SEB91-4

CARGO DOOR LATCH IMPROVEMENT

SK206-40

TITLE CARGO DOOR LATCH IMPROVEMENT.

Figure 1. 206 Cargo Door Latch Improvement (Sheet 1 of 3)

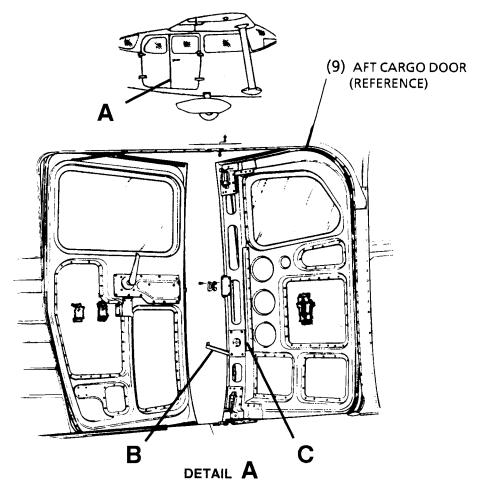
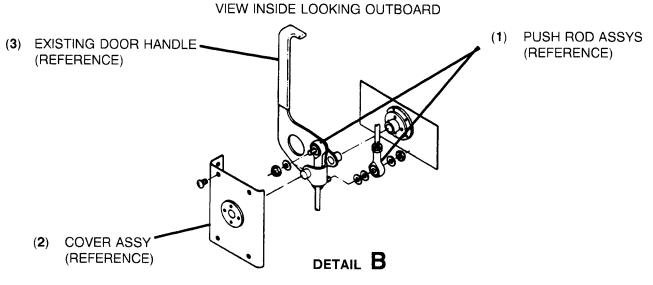
- A. Cargo door latch improvement.
 - 1. (Refer to Figure 1, Sheet 1 thru 3) Remove upholstery panel and trim panel on aft cargo door to gain access to remove door handle assembly. Retain panel and hardware.
 - Remove existing door handle (3) on aft cargo door (9). Discard handle, retain hardware. 2.
 - 3. (Refer to Figure 1, Detail C & View E-E) Place doubler (5) in position on aft side of fwd door channel face per dimensions shown. Using existing holes in doubler (5) as a template, drill and countersink holes (8).

- 4. Secure doubler (5) to door channel (15) using rivets (8).
- 5. Locate and drill hole (16) in door channel (15) per dimensions shown in detail C and view D-D. Deburr hole.

- Install new door handle (11) using retained hardware. Install spring (10) as shown using existing
 hole in handle and hole drilled in door channel. Refer to chapter 3 in the 206 Service Manual for
 rigging procedures if required. Handle should retract to locked position when released with door
 open.

Figure 1. 206 Cargo Door Latch Improvement (Sheet 3 of 3)

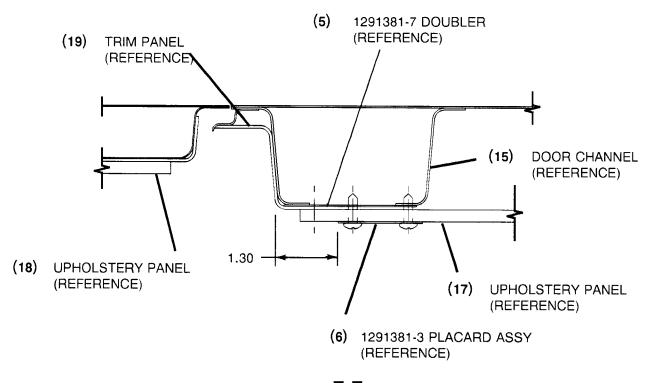
- 7. Replace upholstery panel on aft cargo door with retained hardware removed in step 1.
- 8. Place placard (6) in position as shown. Using existing holes in placard as a template, mark and drill holes (7) thru door channel (15) and doubler (5).

- 9. Install placard (6) to upholstery panel, doubler and door channel using screws (7).
- 10. Place placard (13) in position on fwd cargo door (12) per dimensions shown. Mark and drill holes (14) using existing holes in placard as a template. Remove placard, clean and deburr holes.

- 11. Install placard (13) and secure with existing screw (4) and screws (14).
- B. Make an entry in the airplane logbook stating this Service Kit has been installed.
